CITY OF ALBUQUERQUE

RE: Wintergreen Apartments – Bldg. D
10800 Golf Course Rd NW
Permanent C.O. – Accepted
Engineer's Certification Date: 11/28/23
Engineer's Stamp Date: 08/26/21
Hydrology File: A12D008D

DRAINAGE AND TRANSPORTATION INFORMATION SHEET (DTIS)

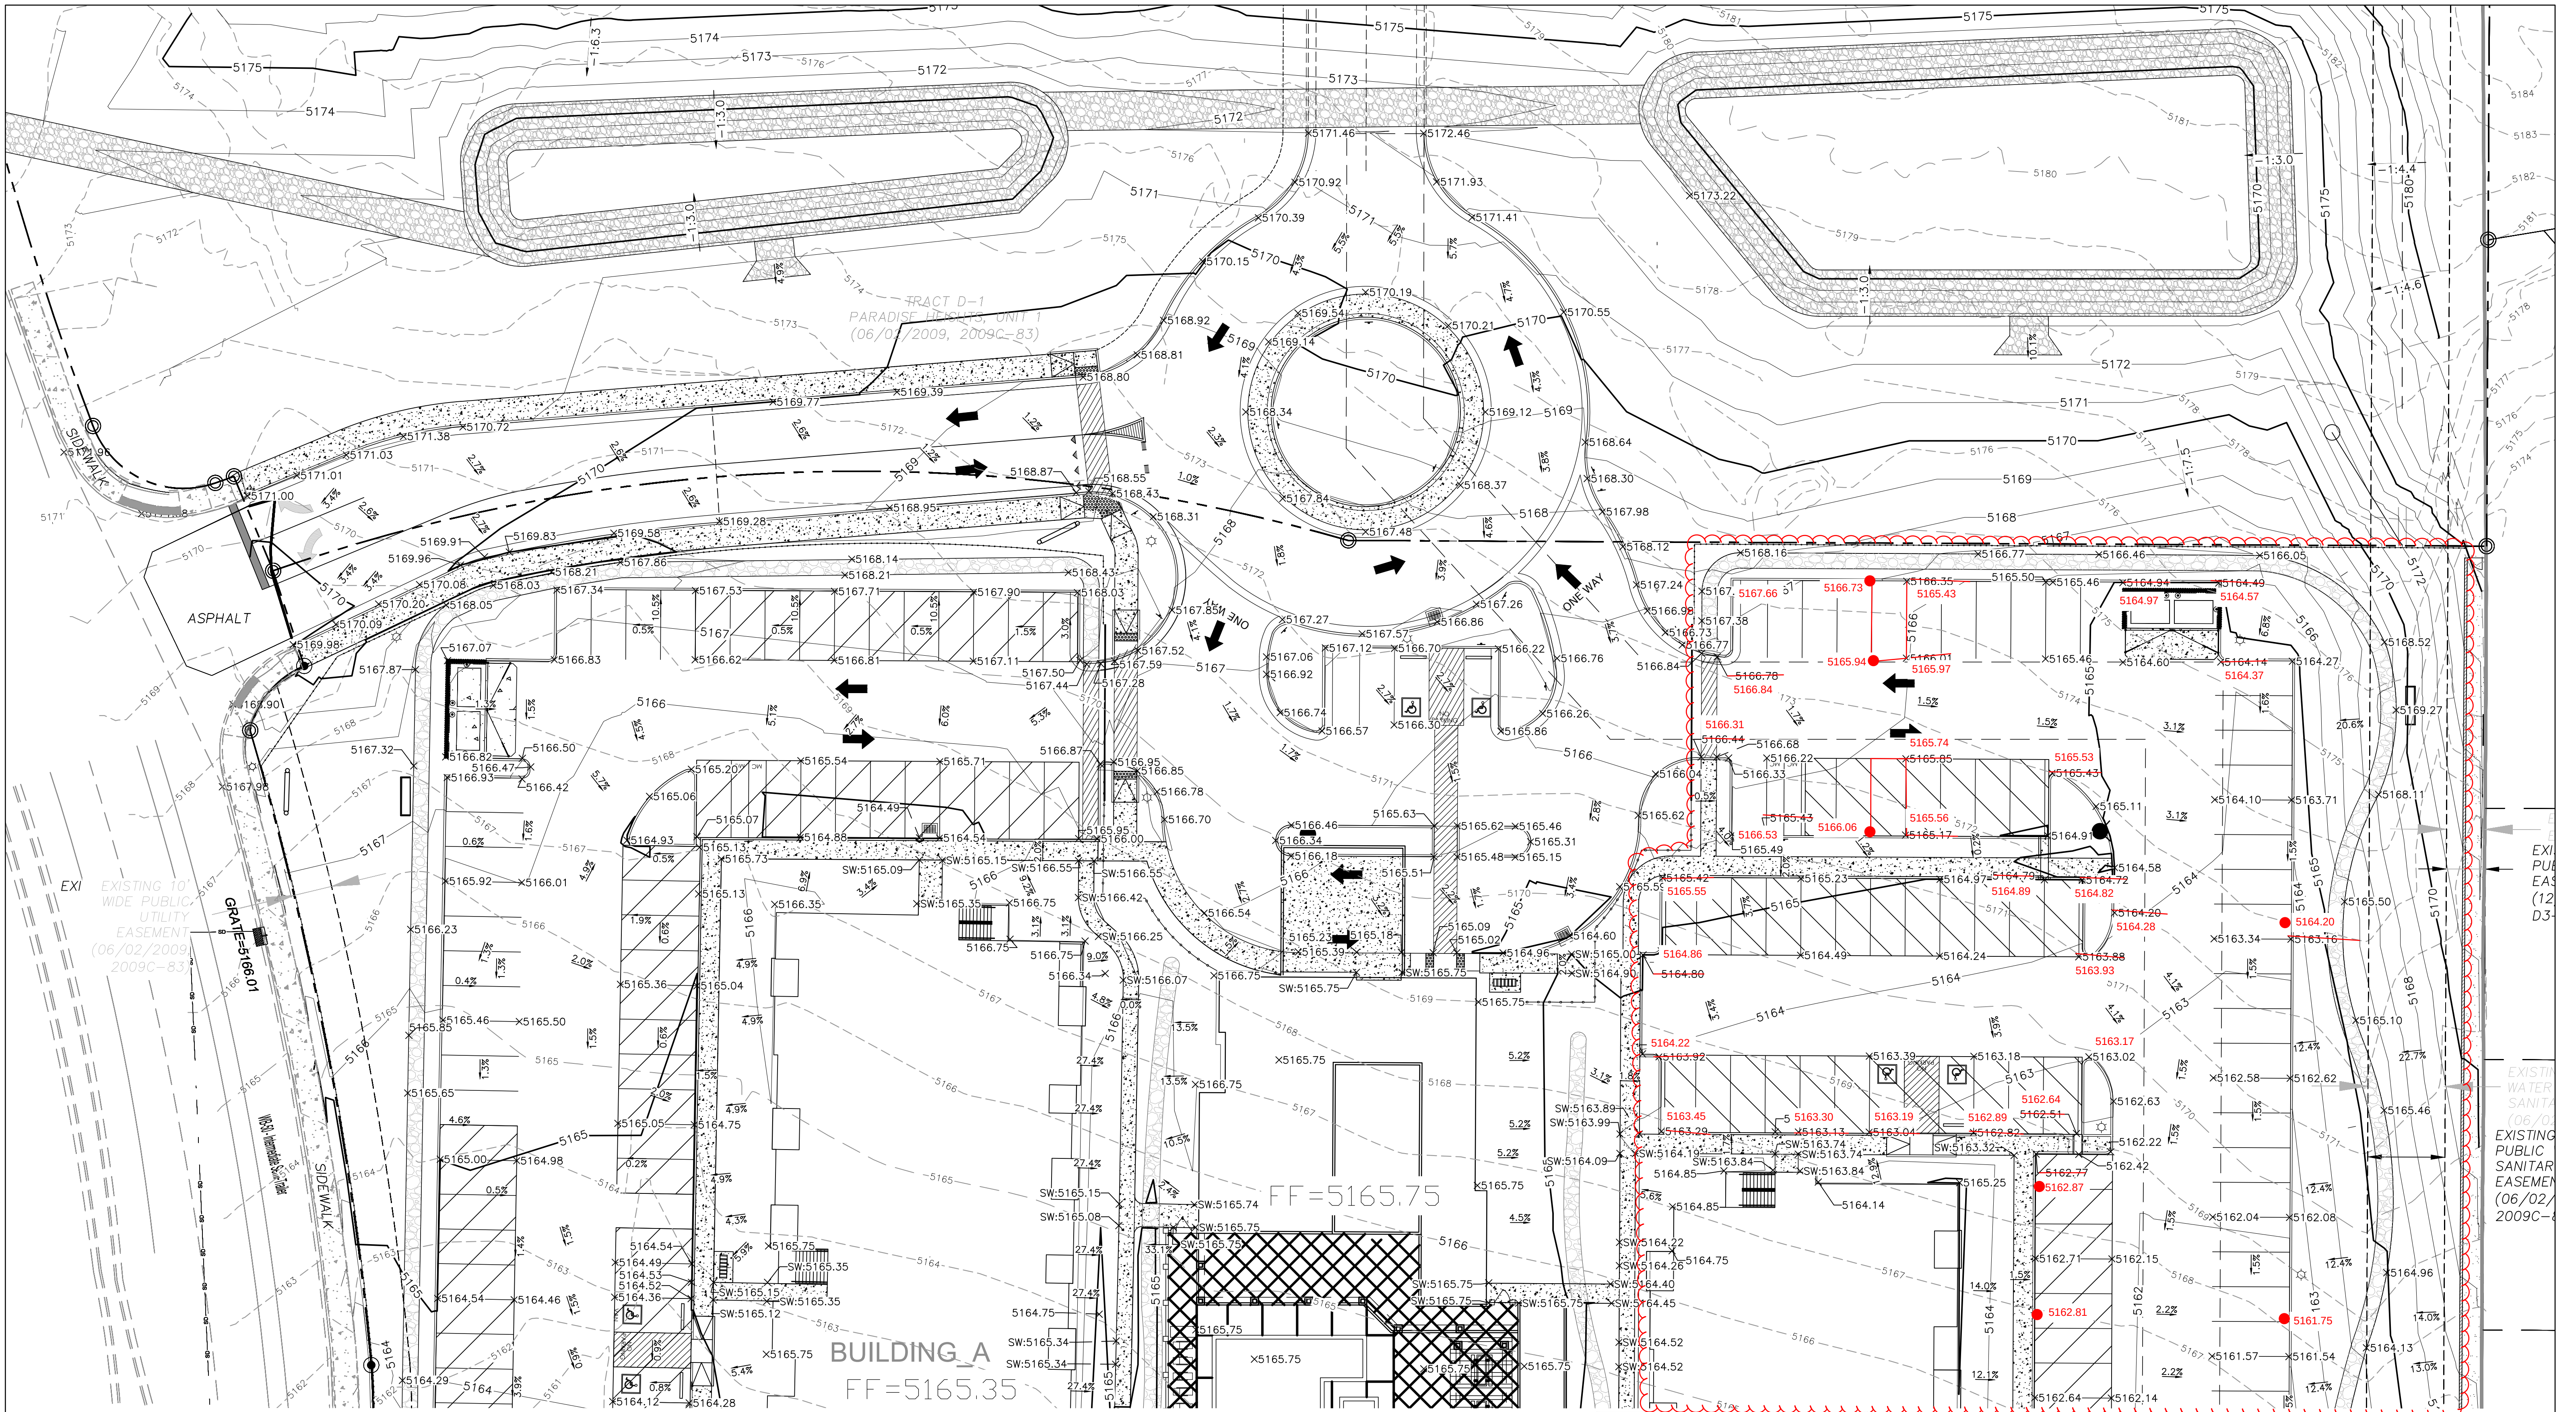
1. The stormwater quality pond needs to be included in the engineer's certification.
2. Engineer's Certification, per the DPM Part 6-14 (F): *Engineer's Certification Checklist For Non-Subdivision* is required.
3. Please provide the executed paper Drainage Covenant (latest revision) printed on one-side only with Exhibit A and a check for **\$25.00** made out to “**Bernalillo County**” for the stormwater quality pond per Article 6-15(C) of the DPM to Hydrology for review at Plaza de Sol.
